MILLSTONE NUCLEAR POWER STATION, UNIT NO. 2

AMENDMENT TO FACILITY OPERATING LICENSE

Amendment No. 29
License No. DPR-65

SAFETY EVALUATION BY THE OFFICE OF NUCLEAR REACTOR REGULATION
SUPPORTING LICENSE AMENDMENT NO. 29 TO FACILITY OPERATING LICENSE NO. DPR-65
NORTHEAST NUCLEAR ENERGY COMPANY
MILLSTONE NUCLEAR POWER STATION, UNIT NO. 2
DOCKET NO. 50-336

FIGURE 3.4-2b

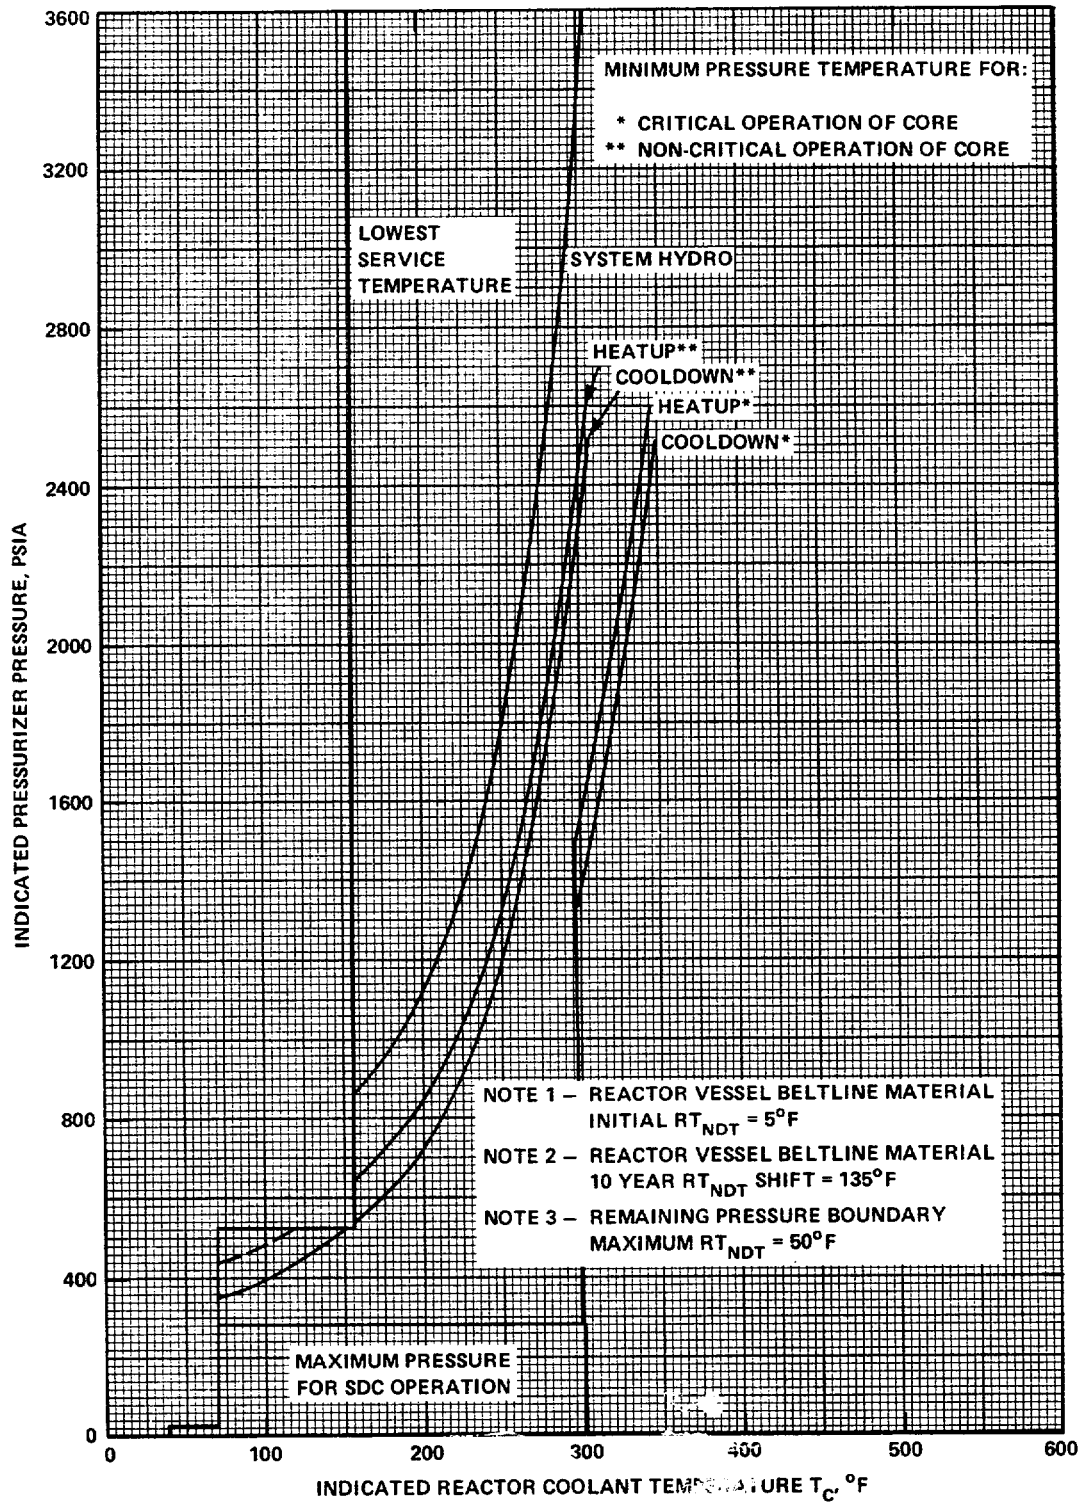
By letter dated February 23, 1977, we informed NNECO that the existing RCS pressure/temperature limits contained in Technical Specification 3.4.9.1 did not have sufficient margin to assure compliance with 10 CFR Part 50, Appendix G, entitled, "Fracture Toughness Requirements". Specifically, the existing limits on pressure and temperature did not conservatively account for the decreased fracture toughness of those areas of the reactor pressure vessel near geometric discontinuities, such as nozzles and flanges, as required by 10 CFR Part 50, Appendix G, Section IV.A.2.b. Our letter of February 23, 1977 requested that NNECO submit proposed Technical Specifications to assure compliance with 10 CFR Part 50, Appendix G.

NNECO responded to the Commission's request in their March 25, 1977 application. NNECO proposes that the RCS pressure/temperature limits, applicable from 0 to 2 years of full power reactor operation be replaced by those limits that would have been applicable during the period from 2 to 10 years of full power operation. This change is appropriate and conservative because reactor pressure vessel material toughness, i.e., resistance to brittle fracture, decreases over the life of the facility due to neutron irradiation induced material changes. Thus, the limits applicable later in reactor vessel life (i.e., 2 to 10 year period), require RCS temperatures that have to be increased over the previous limits in order to achieve the same margin to brittle fracture associated with the same RCS pressure.

Based upon the above discussion, we conclude that NNECO's proposed change in pressure/temperature limits provide sufficient margin to brittle fracture to assure compliance with 10 CFR Part 50, Appendix G. Moreover, with continued neutron irradiation of the reactor vessel, the "belt line region" (an initially lower stressed region, adjacent to the reactor core) will lose fracture toughness at a greater rate, due to the higher neutron flux, than the higher stressed regions such as the nozzles which are exposed to lower neutron flux. Thus, after continued irradiation the beltline region will become limiting and the initially high stressed regions will not be influential with regard to determining brittle fracture effects on operation.

Accordingly, NNECO's proposal to implement at this time the 2 to 10 years period of full power RCS pressure/temperature limits, in Technical Specification 3.4.9.1, is acceptable.
